RAPID UPDATE

Rapid Update 658/669

Maserati Granturismo – Replacement of air springs

Clarifications to the technical cycle

Start with the wheels pointing straight Turn the wheels fully locked to the Right Turn the wheels fully locked to the Left

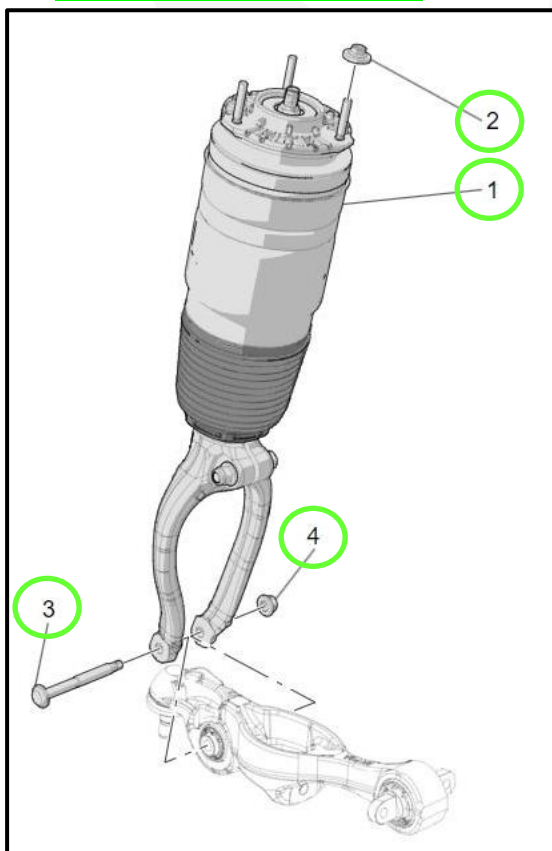
2. Carry out a "Lock to Lock" maneuver. Starting with the steering wheel centered and wheels pointing straight ahead. Then turn the steering wheel completely to the right until reaching the end of its travel. Wait 30 seconds (while visually monitoring ride height) and repeat the operation by turning the steering wheel all the way to the left, always reaching the end of its travel.

3. Make sure the vehicle has not sagged, which is a sign that the shock absorbers have deflated.

4. Repeat the test at least 3-4 times.

- **OK ► NO lowering of the vehicle occurred**, the procedure is finished. No further action needed.
- **NOT OK ► Lowering of the vehicle occurred**. Both front shocks will need to be replaced using the "new" PN's. **Open BOL as "FACTORY INFORMATION" attach a video and pictures of the parts label and blue mark, and await further instructions.**

Components to be replaced

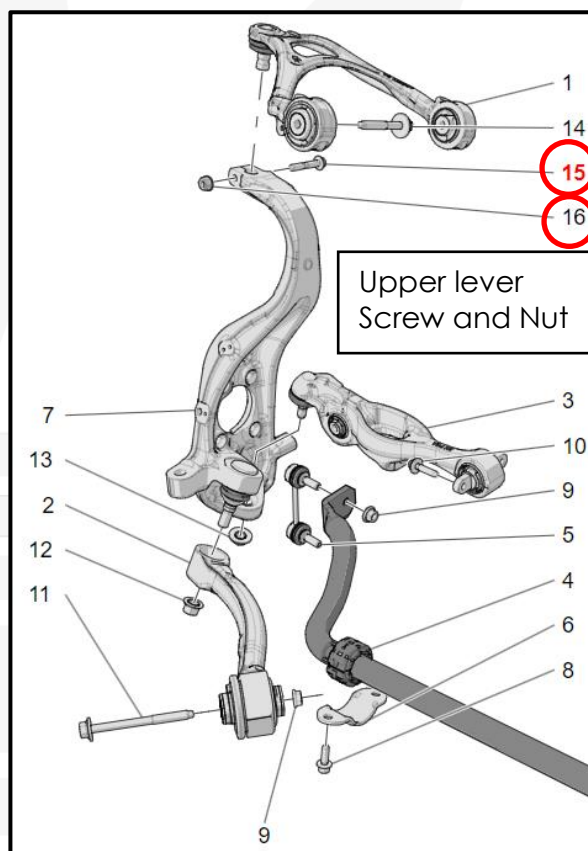
NOTE: In addition to replacing the shocks, new hardware will also need to be replaced per RU 658/669.

Please order the following "new" PNs:

SPARE PARTS TABLE (M189)	Pos	PN	QTY
RH FRONT SHOCK ABSORBER	1	670309018	1
LH FRONT SHOCK ABSORBER	1	670309015	1
Shock absorber upper nuts	2	675001506	6
Shock absorber retaining screw	3	670159150	2
Shock absorber nut	4	675001189	2
